Subject: An Application for a Minor Permit Modification for
Replacement of the Perimeter Gas Monitoring Probes
Permit No. SO49-0199726-015
J.E.D. Solid Waste Management Facility
Omni Waste of Osceola County, LLC

**REPLACEMENT OF PERIMETER GAS
MONITORING PROBES – APPLICATION
FOR A MINOR PERMIT MODIFICATION**

J.E.D. SOLID WASTE MANAGEMENT FACILITY

Osceola County - SW
JED Solid Waste Management Facility
Permit # SO49-0199726-005 and SC49-0199726-004
WACS # 89544
Response to "Status Report of Methane Gas Migration Investigation"

NOT TO SCALE	
Typical Replacement Gas Monitoring Probe Construction Detail WASTE SERVICES OF FLORIDA, INC. J.E.D. SOLID WASTE 1501 OMNI WAY ST. CLOUD, FLORIDA	
	FIGURE 2
TAMPA, FL	MARCH 2011

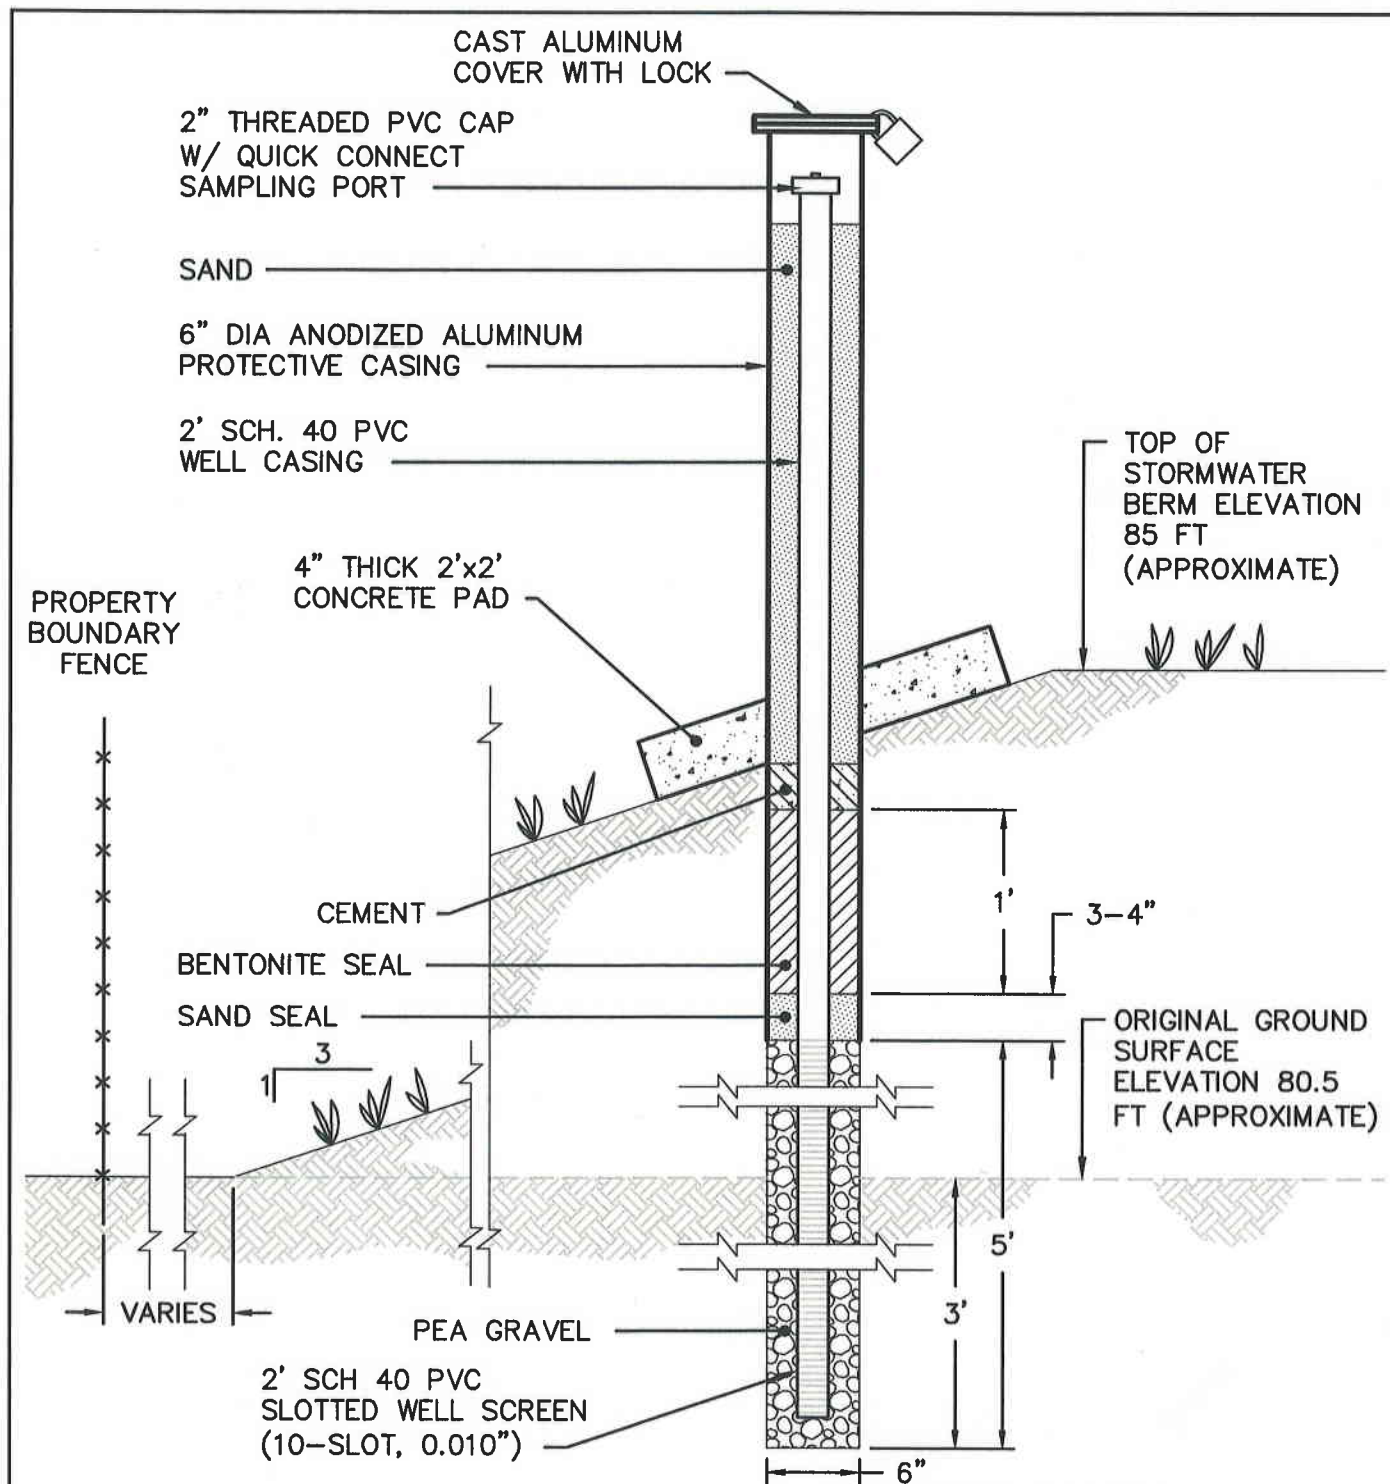
- Abandon the existing permanent gas probes.
- Replace them with permanent gas probes in the same location (in the landfill perimeter berm with an elevation of approximately 85' NGVD).
- Construct the new probes such that the bottom of the screened interval will be at approximately 77.5' NGVD.
- The screened length should be five feet or six inches below land surface which is less.

These changes will require a minor modification to the existing solid waste operating permit. The submittal must identify each location that will have a new well. It must show a detail drawing for the new landfill gas probes. Although the landfill gas probe changes do not affect the gas collection and treatment system, I recommend you check with the Air Program regarding whether they have permitting requirements.

log and completion diagram for each replacement perimeter gas probe will be prepared and submitted as part of an installation summary report. A detail of the proposed replacement perimeter gas monitoring probe (typical) construction is shown on Figure 2.
